## Safety Advisory

### G1 SCBA & RIT System – High Pressure Relief Valve

January 13, 2017

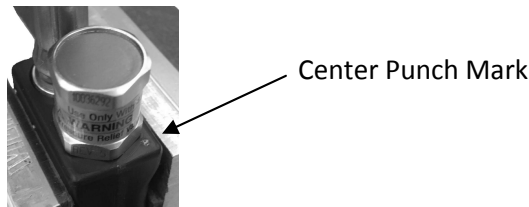
Service is required to re-torque the high pressure relief valve on all 4500 psig G1 SCBA with a manufacturing date code before '5016' (50<sup>th</sup> week of 2016) and also on SCBA and RIT Systems with no date code. If the SCBA date code is present, it is marked on the hand wheel assembly as shown in the photo below. The service must be performed by an MSA certified CARE technician and will be free of charge. 2216 psig SCBA and RIT Systems do not require this service.

Please contact your local MSA Fire Service Distributor to arrange for this re-torquing service as soon as possible. If you have an MSA certified CARE technician on staff, they may perform this service. For identification purposes, SCBA serviced to re-torque the relief valve will be marked with a center punch mark on the hand wheel manifold as shown in the photo below. A similar mark will identify RIT Systems. New production will not have the punch mark.
